Technical Bulletin 150

New 'HPPM' MiniPID pellet: Changing Over

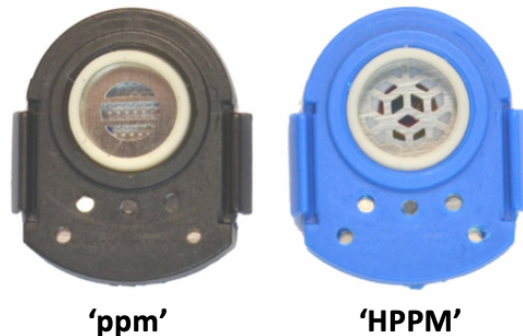
The difference in product can be clearly distinguished. The new 'HPPM' pellet is **blue** in colour, compared to the **black** 'ppm' pellet, as shown in the photo below:

As the new 'HPPM' pellet is designed to be used *only* with our new higher-output lamps, the 'HPPM' and 'ppm' pellets are *not directly interchangeable*.

To this end an 'HPPM pellet' upgrade for 3-pin 'ppm' pellets (P/N A-846229 or MSF) or ppm lamps (LA4TM600) will be supplied as a single package consisting of HPPM pellet and the high output lamp (LA42SM60). This is to ensure that new HPPM pellets are always used with our new high-output lamps. When received, both HPPM pellet and lamp should be exchanged together to ensure optimal performance.
